## CHAPTER 4 SAFETY CLEARANCE, FREEBOARD AND DRAUGHT MARKS

#### 4-3 General DRAUGHT MARKS AND FREEBOARD MARK

Fig. 4-3.10

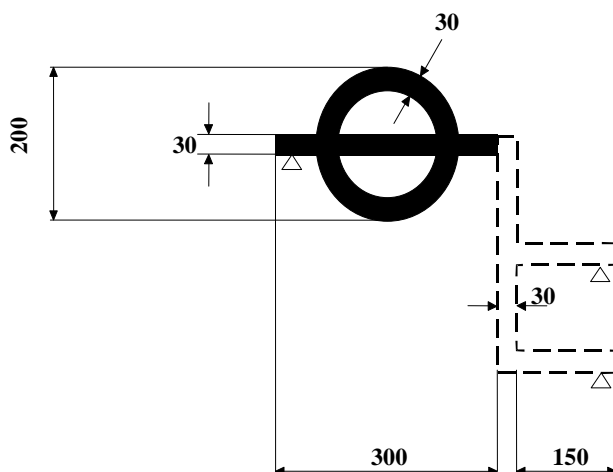
The freeboard mark for zones 1 and 2 shall **must** consist of a ring intersected through its centre by a horizontal line which shall be supplemented if necessary by additional freeboard lines.

The width of the ring and of all the other lines of the freeboard mark shall be 30 mm; the outer diameter of the ring shall be 200 mm; the length of the horizontal line intersecting the ring shall be 300 mm; and the size of the numerals designating the zones shall be 60 x 40 mm (Figure 4-3.10).

If the vessel is intended to navigate in several navigation zones, a vertical line *and* additional freeboard lines 150 mm in length shall be applied forward of the centre of the ring.

**The lower edge of each freeboard line shall correspond to the freeboard prescribed for the navigation zone concerned.**

The freeboard mark and the measurement draught mark may be combined. In this case, the width of the **freeboard mark line** rectangle (the width of the upper line if there are a

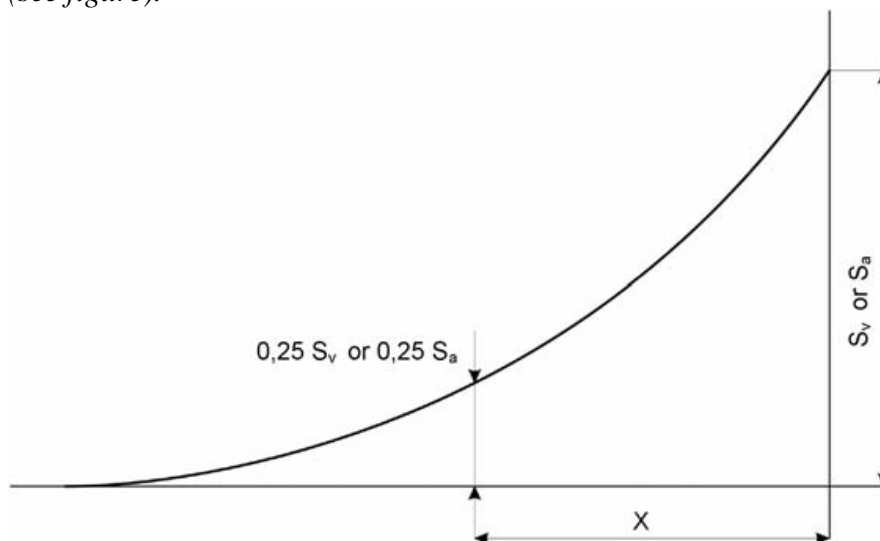
4.02(5) 4-4.2.5 The effective aft/forward sheers  $Se_v/Se_a$  are calculated using the following formulae:

$x$  is the abscissa, measured from the extremity of the point where the sheer is  $0,25 S_v$  or  $0,25 S_a$  (see figure).
